# INDIAN BEND WASH ARIZONA

FINAL ENVIRONMENTAL STATEMENT

October 1973

SUMMARY  
INDIAN BEND WASH  
MARICOPA COUNTY, ARIZONA

TABLE 1  
CENTRAL PHOENIX STATION  
AIR QUALITY PARAMETERS

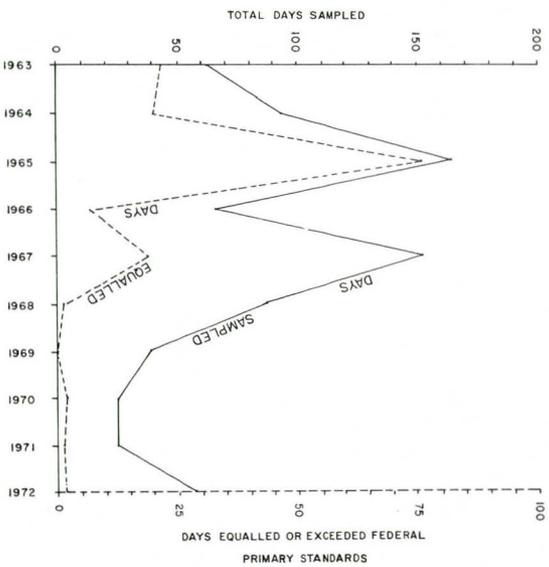
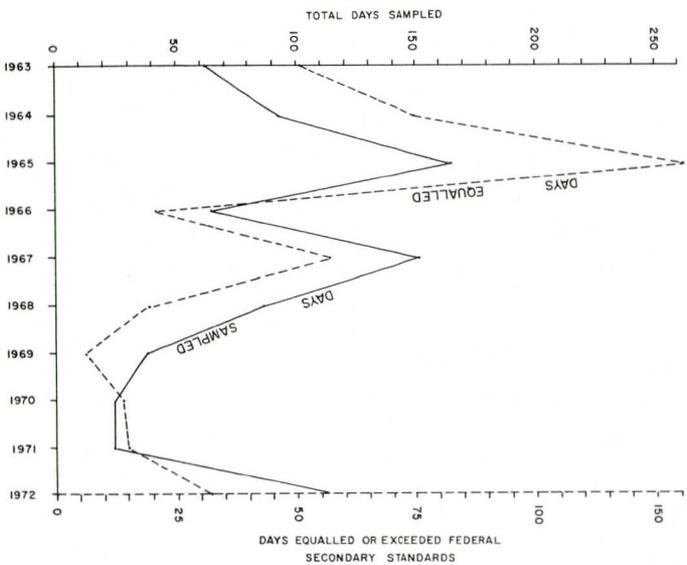
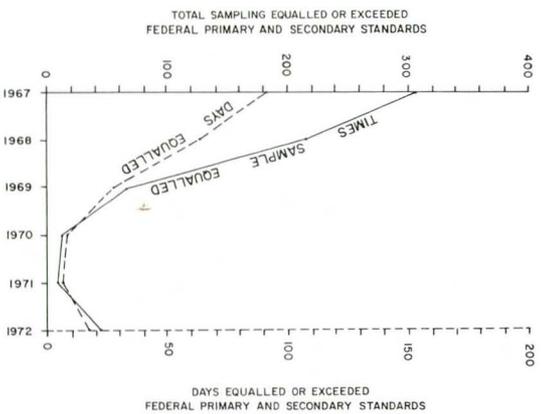
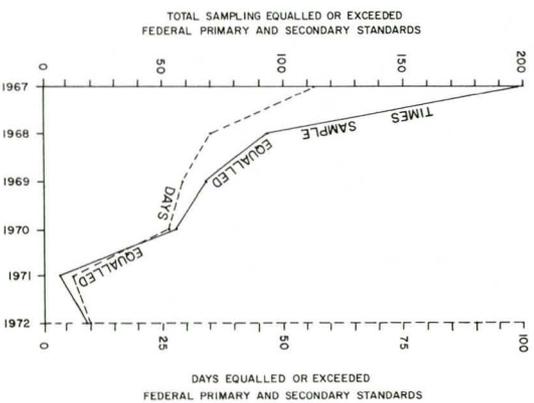
Comment: The data on air quality (Table 1) could be presented more clearly by having the ordinate for "Total Days Sampled" coincide with the ordinate for "Days Equaled or Exceeded Standards," and by adding a third curve, "Fraction of Sampled Days Which Equaled or Exceeded Standards". Since air quality is only a peripheral consideration to this project, this section might be omitted.

Response: The data on air quality is believed pertinent and adequate in its present format.

**RECOMMENDED PLAN OF IMPROVEMENT**

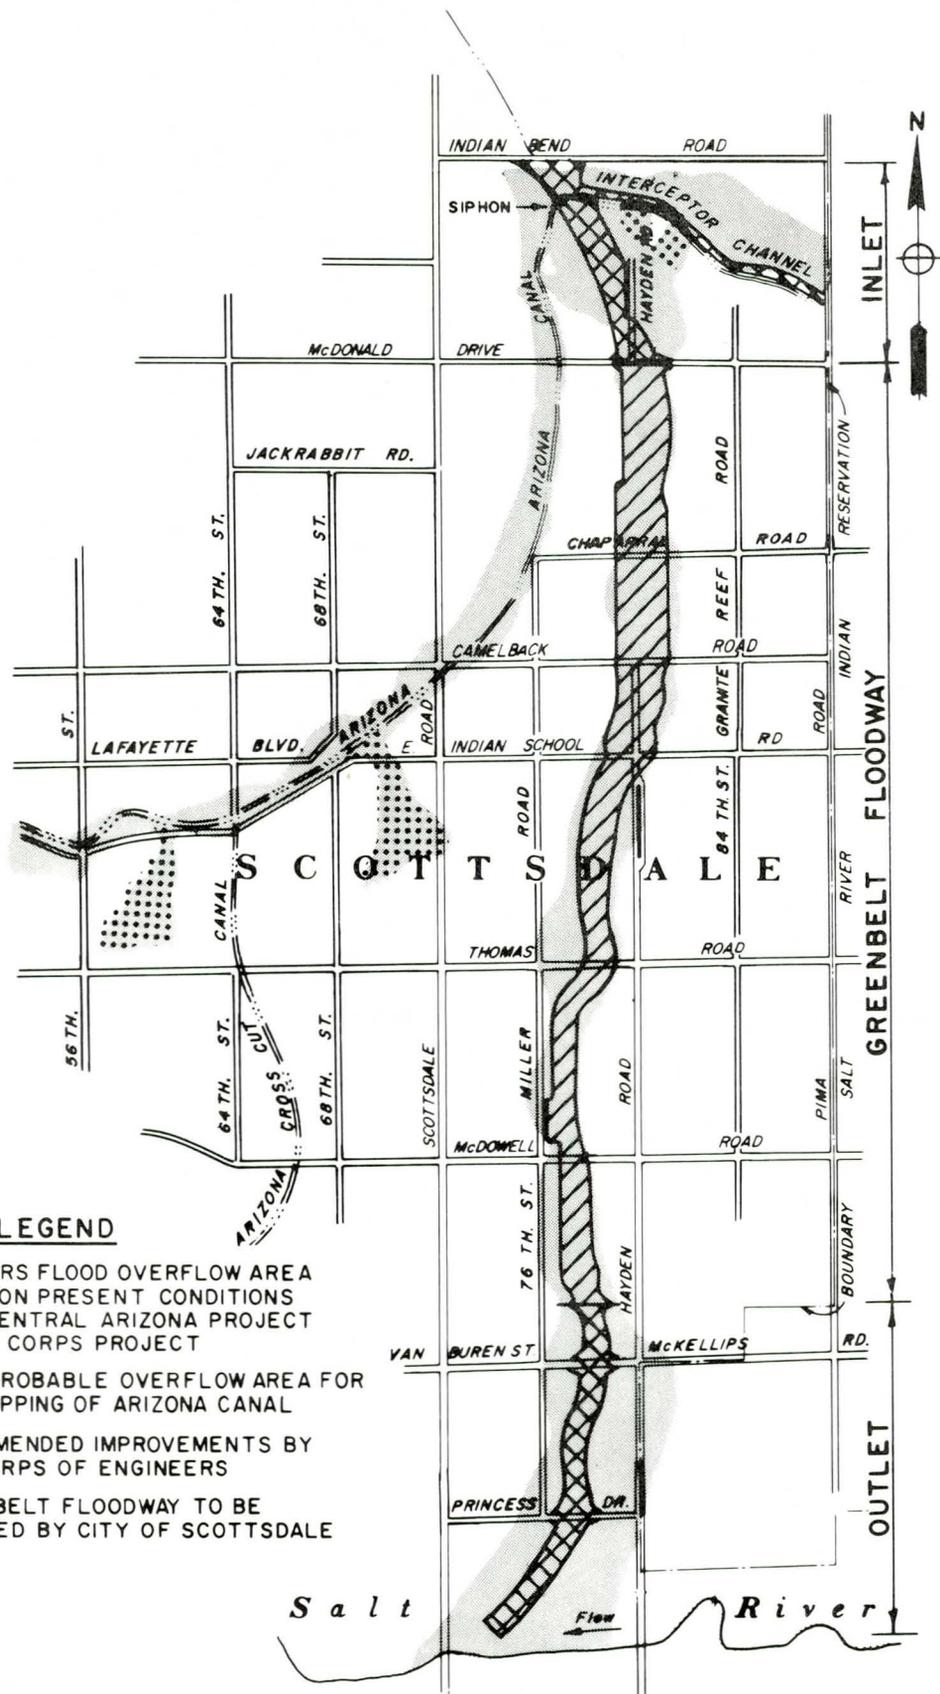
Comment: On plate 1, indicate flow on west side of Arizona Canal from Lincoln Road to Indian Bend Wash is to the north. Delete overshoot over Arizona Canal in vicinity of Lincoln Road.

Response: Plate 1 has been modified.

PHOTO 6. Looking westward at the landfills, trash and garbage piles that are near the confluence of Indian Bend Wash and the Salt River.

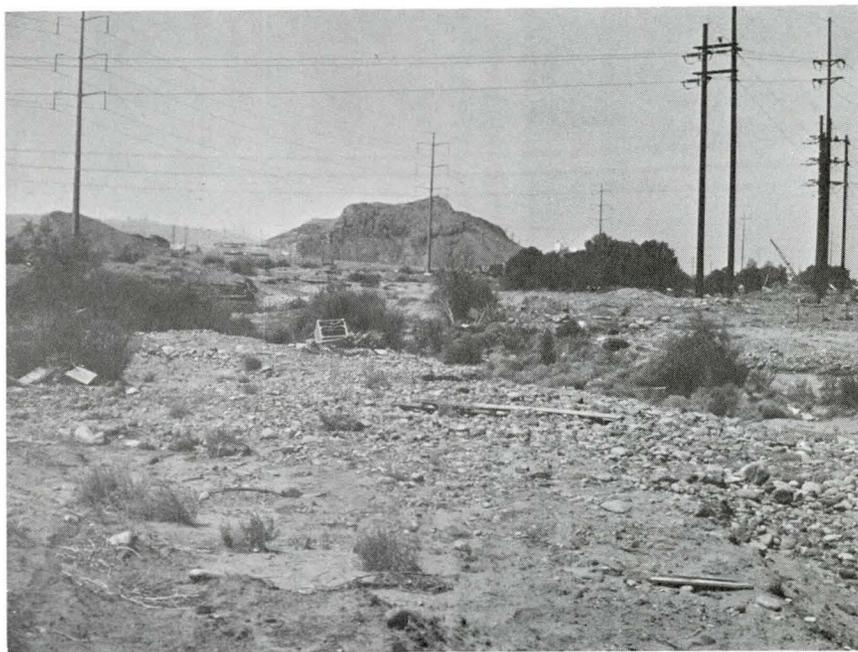
- d. We have found it necessary to provide supplemental water to plantings during the establishment period. The statement is silent on this subject and costs are not shown in the discussions of operation and maintenance. It would be extremely difficult to vegetate the soils shown in Photo 6. (See paragraph 75c.)
